G Slurry Displacement Piles

Subject: Gamma-Gamma Logging Test Results: Pile 1 at Bent 7 of the SR4 Crosstown Viaduct

Subject: Combined Gamma-Gamma Logging (GGL) and Cross-Hole Sonic Logging (CSL) Test Results:
Pile 1 at Bent 7 of the SR4 Crosstown Viaduct

Pile Information

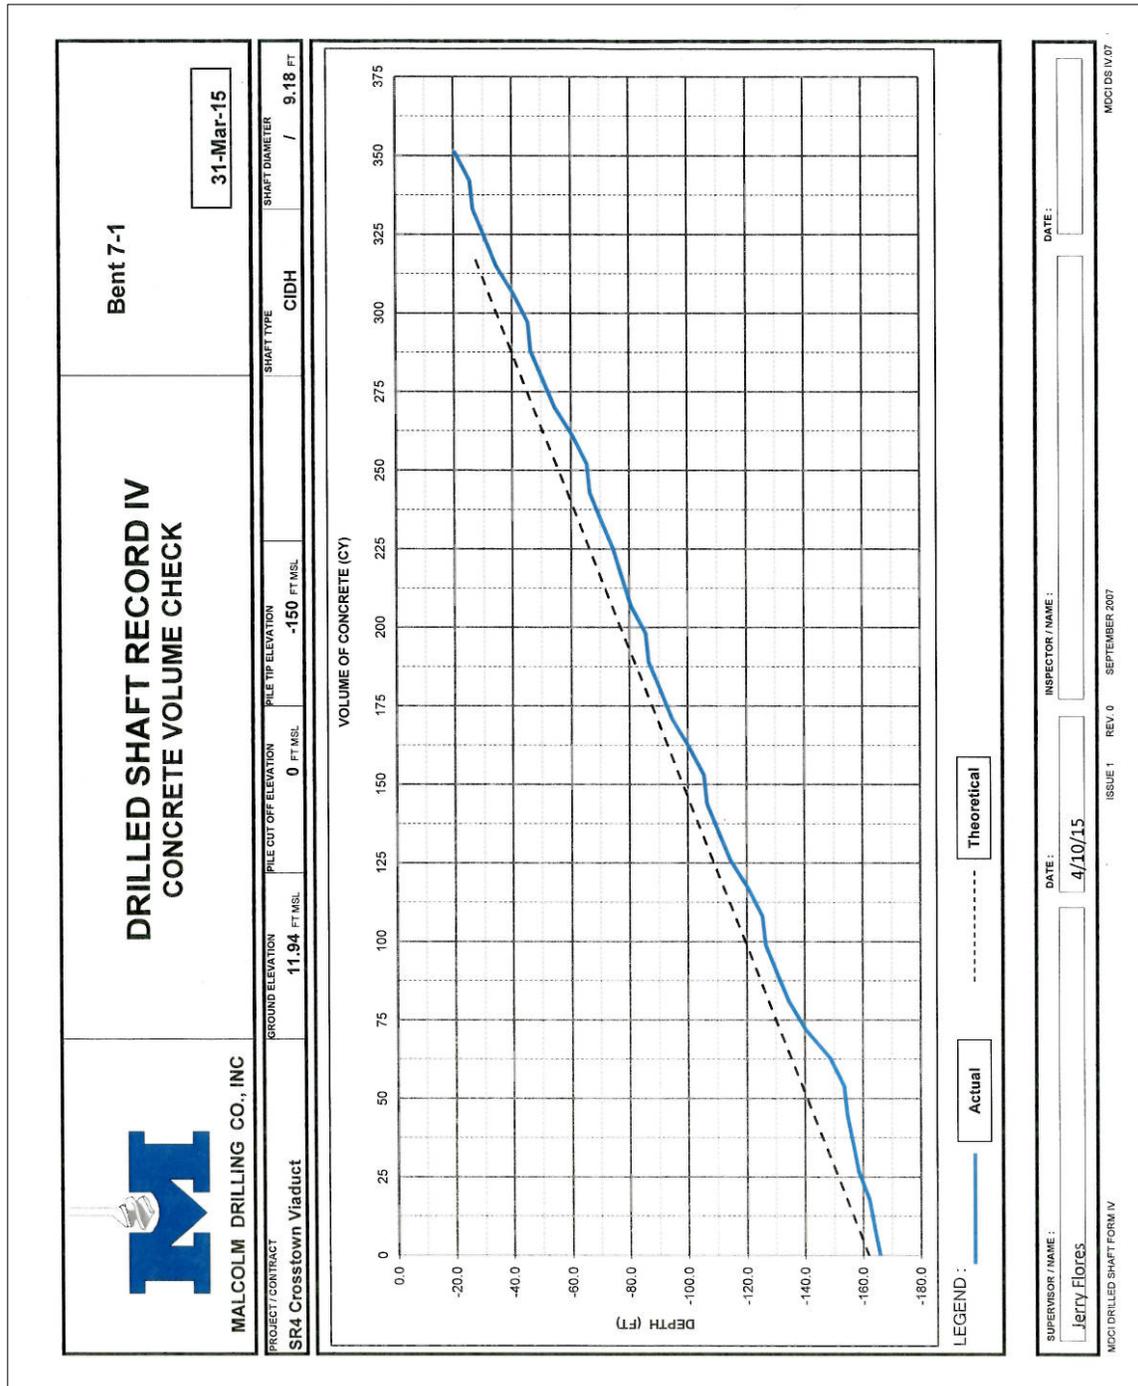
This Office also recommends that OSC inspect the top of pile concrete prior to completing pile construction above the reported construction joint elevation. Further, this Office recommends that pile designer's review the condition of over 4 feet of untested concrete at the bottom of the pile.

This Office also recommends OSC review the Contractor's plan for placing inspection pipes considering the bottom of inspection pipe elevation, as reported, indicates inspection pipes do not extend to the bottom of the reinforcing steel cage as required by the specifications.

Gamma-Gamma Logging Acceptance Test Results

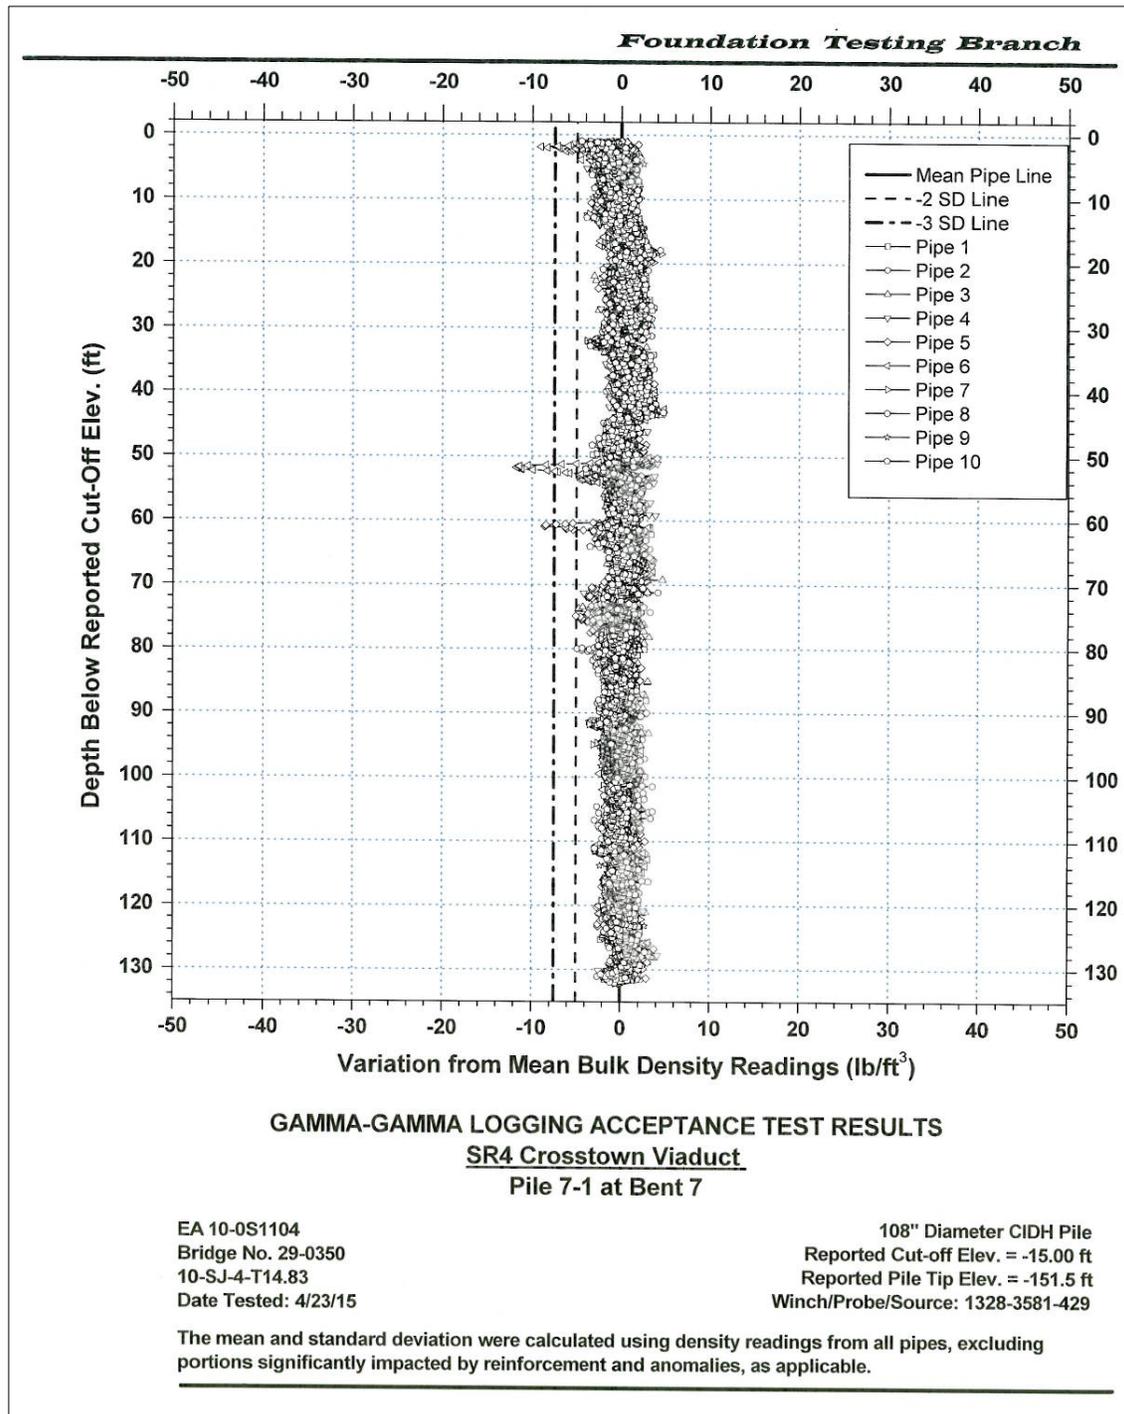
A GGL graph depicting the variation from mean bulk density versus depth for Pile 7-1 at Bent 7 is presented in Appendix C. The mean and standard deviation criteria set was derived from GGL readings of the tested lengths of the inspection pipes, excluding portions significantly impacted by reinforcement and anomalies, as applicable. The reported locations of inspection pipe couplers were considered in the analysis. For each inspection pipe, separate mean densities were calculated for the known differences in the steel reinforcement schedule. Testing was performed in the completely submerged condition using a submerged probe calibration. GGL results are presented in Table II.

Pile (Section)	Approx. Depth ⁽¹⁾ (ft)	Approx. Elevation ⁽²⁾ (ft)	GGL Pipe(s)	Data Description
1 (A-A)	51.4' to 52.3'	-66.4' to -67.3'	6	GGL detected an anomaly at one inspection pipe. Depth of anomaly is near the reported location of a PVC coupler. However, the anomalies magnitude of deviation from mean density is not consistent with a PVC coupler. May affect up to 10% of the pile cross-section at this depth range.

This Office recommends rejection of Pile 7-1 at Bent 7 based on the GGL test results. Please see the Pile Design Data Form (PDDF) in Appendix D and refer to Caltrans BRIDGE CONSTRUCTION MEMO 130-10.0 (June 30, 2014) for guidance in addressing rejected CIDH piles. This Office will conduct Cross-Hole Sonic Logging at Pile 7-1 to further evaluate the size of reported anomalies if requested by the OSC.

Gamma-Gamma Logging Acceptance Test Results

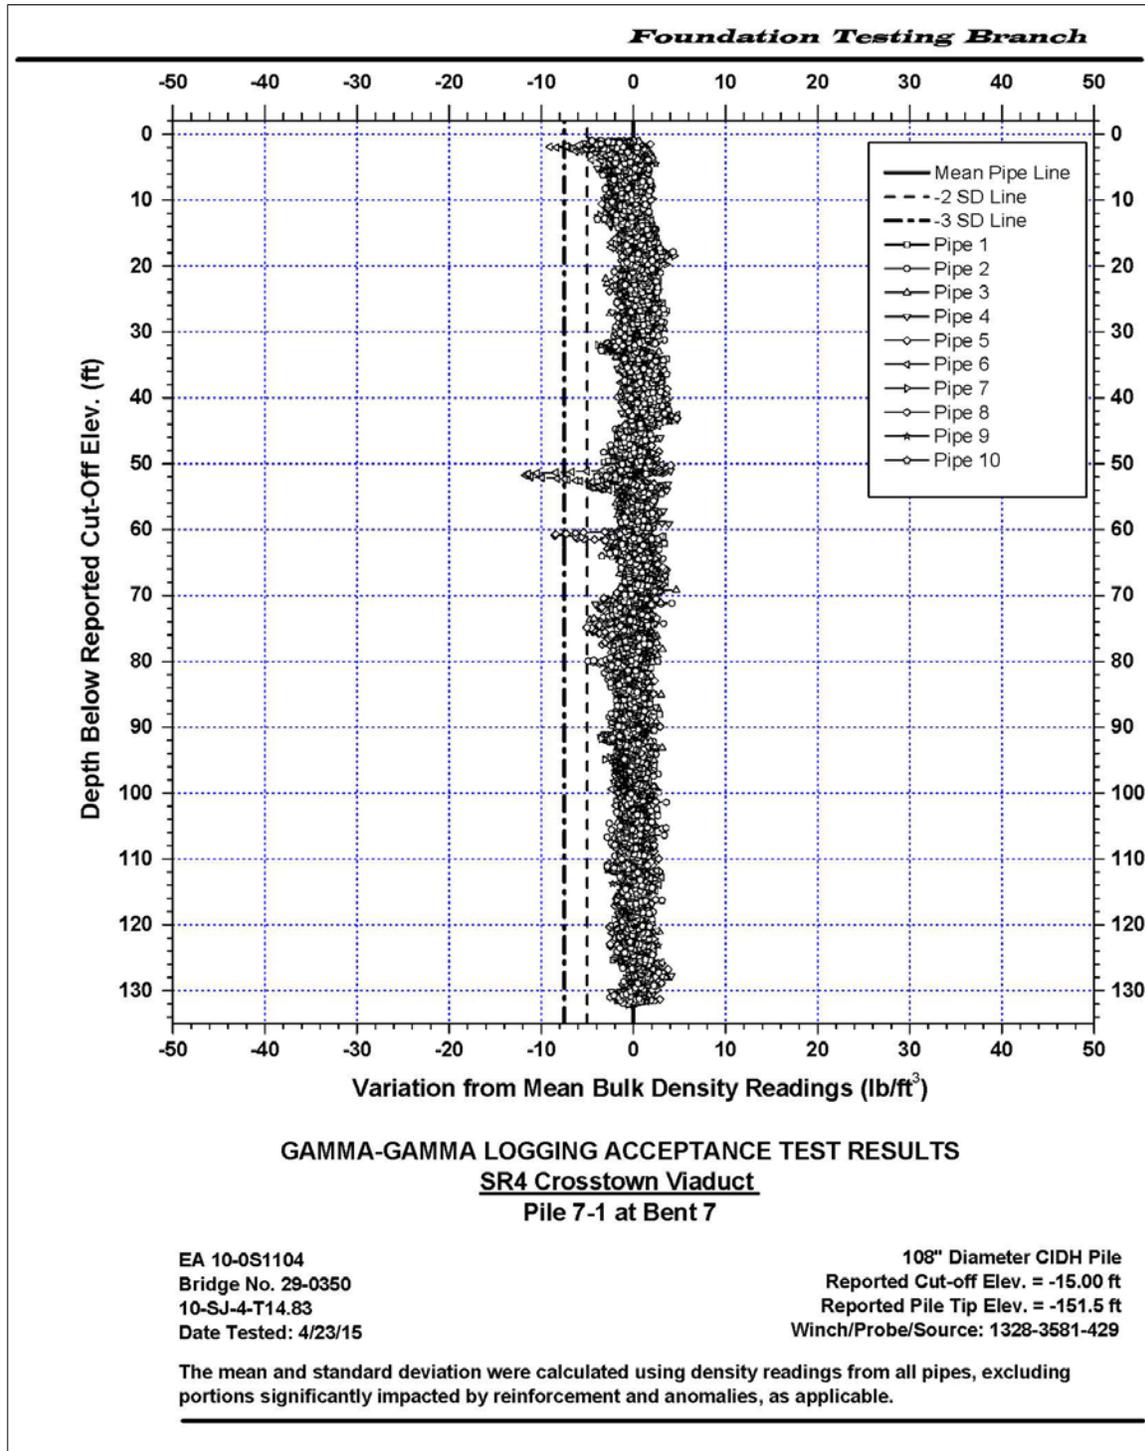
The previously reported GGL graph depicting the variation from mean bulk density versus depth for Pile 7-1 at Bent 7 is presented in Appendix C. The mean and standard deviation criteria set was derived from GGL readings of the tested lengths of the inspection pipes, excluding portions significantly impacted by reinforcement and anomalies, as applicable. The reported locations of inspection pipe couplers were considered in the analysis. For each inspection pipe, separate mean densities were calculated for the known differences in the steel reinforcement schedule. Testing was performed in the completely submerged condition using a submerged probe calibration.

File (Section)	Approx. Depth ⁽¹⁾ (ft)	Approx. Elevation ⁽²⁾ (ft)	GGL Pipe(s)	CSL Pipe Pair(s)	Data Description
1 (A-A)	51.4' to 52.3'	-66.4' to -67.3'	6	--	GGL detected an anomaly at one inspection pipe. Depth of anomaly is near the reported location of a PVC coupler. However, the anomaly's magnitude of deviation from mean density is not consistent with a PVC coupler. No anomalies detected by CSL at the same depth range (Pipe Pair Combinations 5-6, 6-7, and 5-7) May affect up to 2% of the pile cross-section at this depth range.

This Office recommends continued rejection of Pile 7-1 at Bent 7 based on the combined GGL and CSL test results. Please see the revised Pile Design Data Form (PDDF) in Appendix F and refer to Caltrans BRIDGE CONSTRUCTION MEMO 130-10.0 (June 30, 2014) for guidance in addressing rejected CIDH piles.

Cross-Hole Sonic Logging Test Results

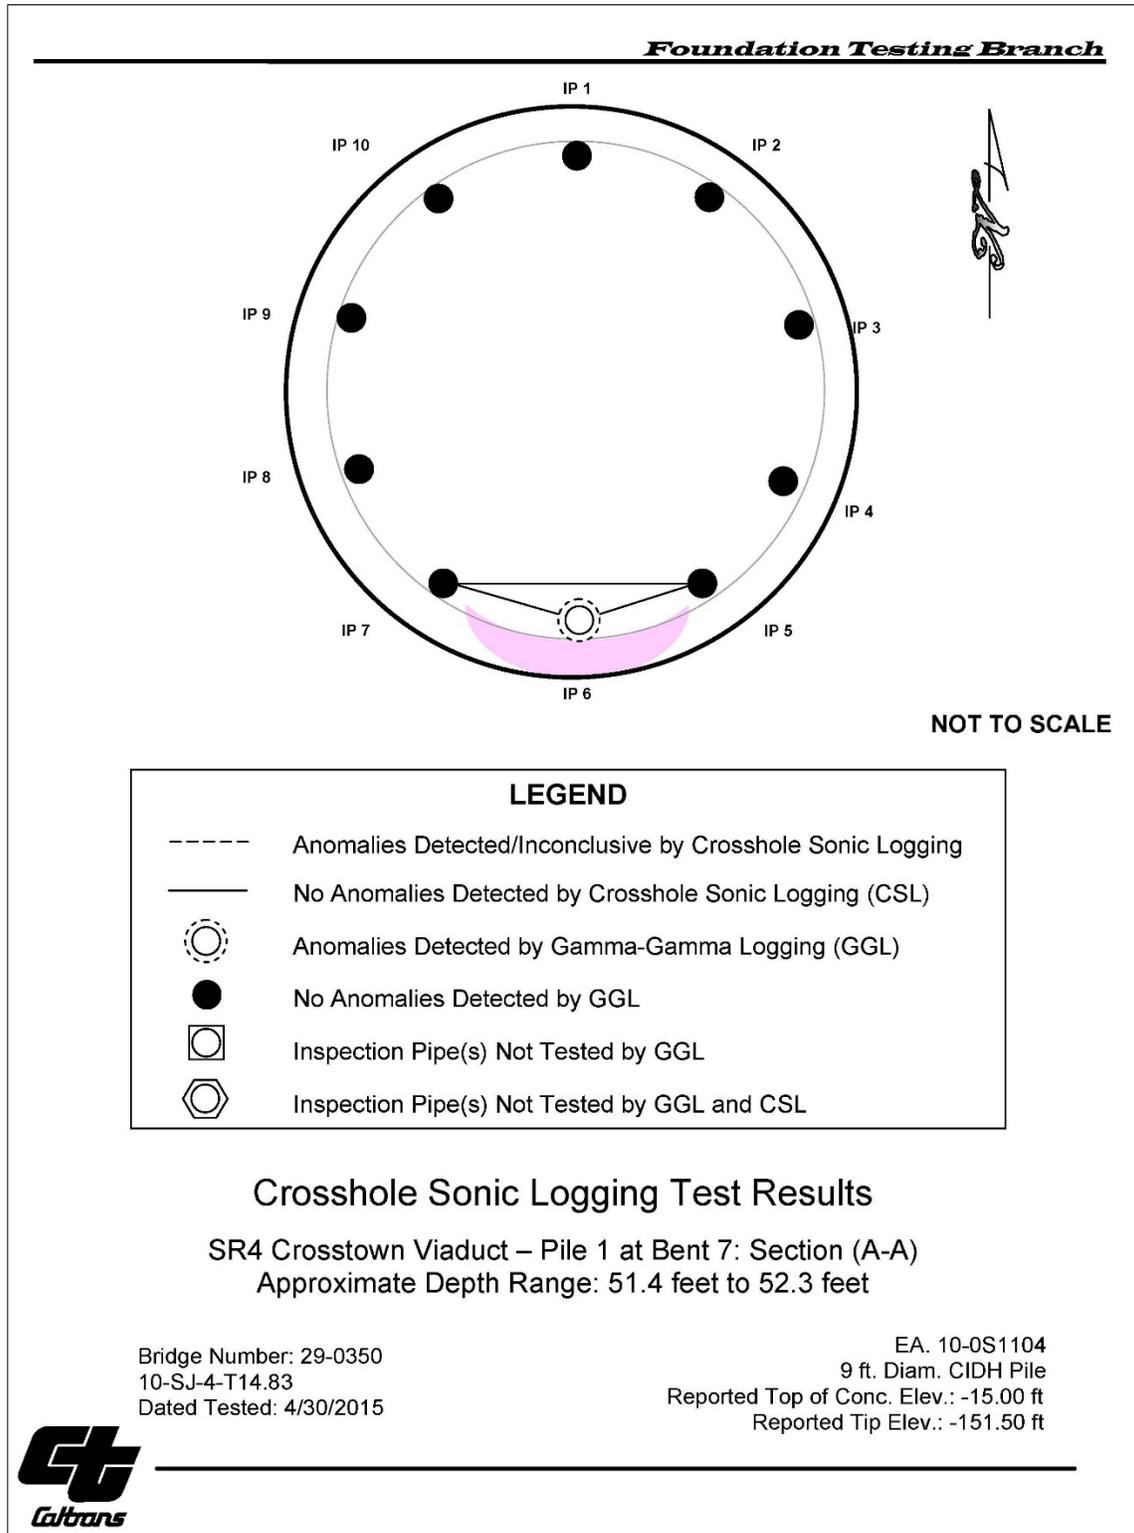
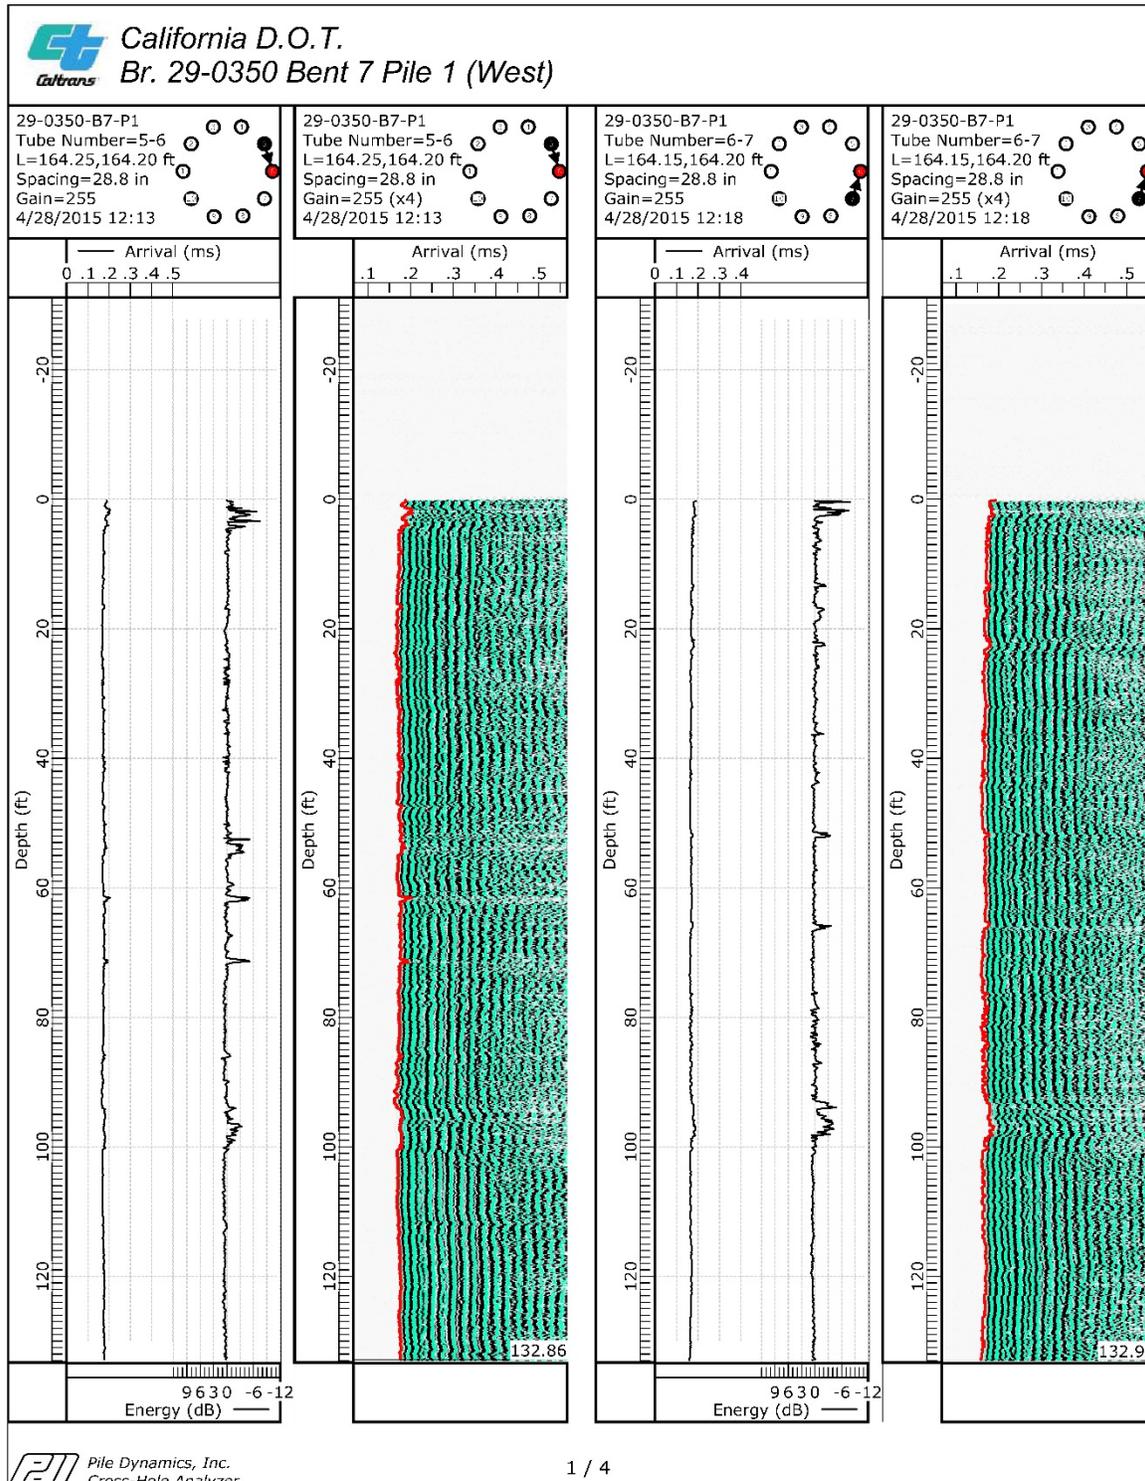
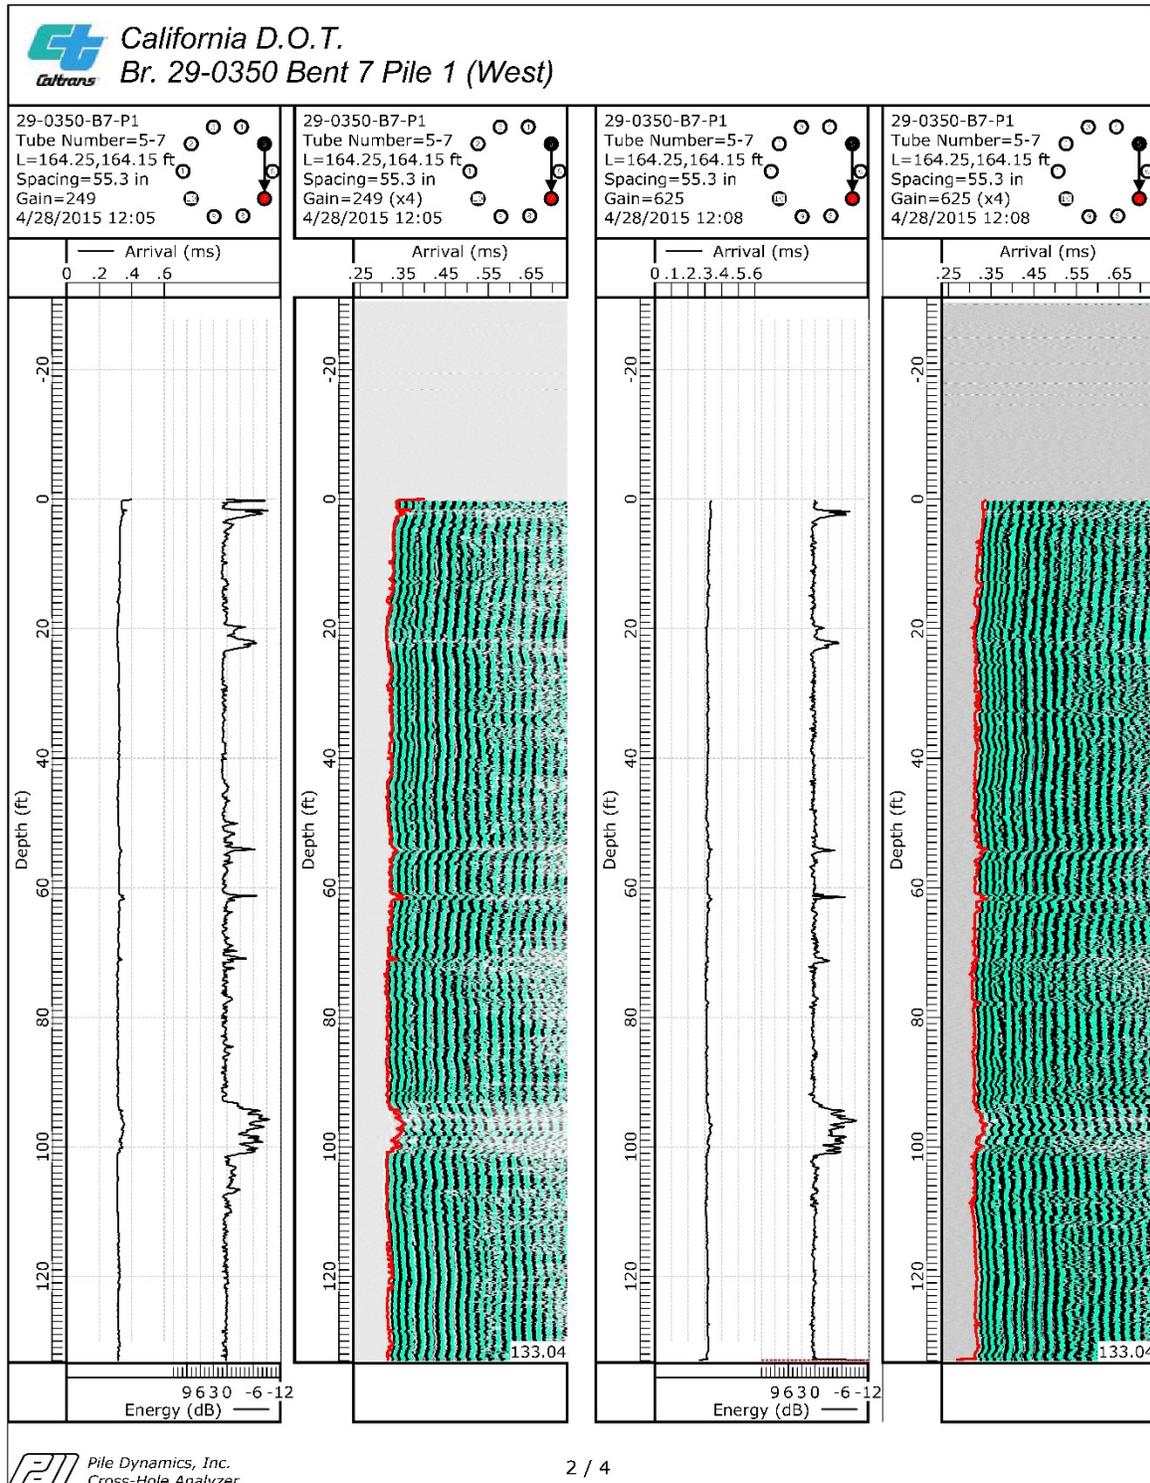
Plots presenting the CSL compression wave arrival times and signal energy as a function of depth for the subject piles are presented in Appendix D. The general criteria for analyzing CSL results are also included in Appendix E. A summary of the combined GGL and CSL analyses are presented in Table II and shown in a section view included in Appendix D.

CSL was conducted for three profiles (Inspection Pipes 5-6, 6-7, 5-7) representing an inside boundary of the anomaly reported in the GGL report. The anomaly was not found in any of the three profiles indicating the actual location is likely contained to the pile perimeter adjacent to Inspection Pipe 6.
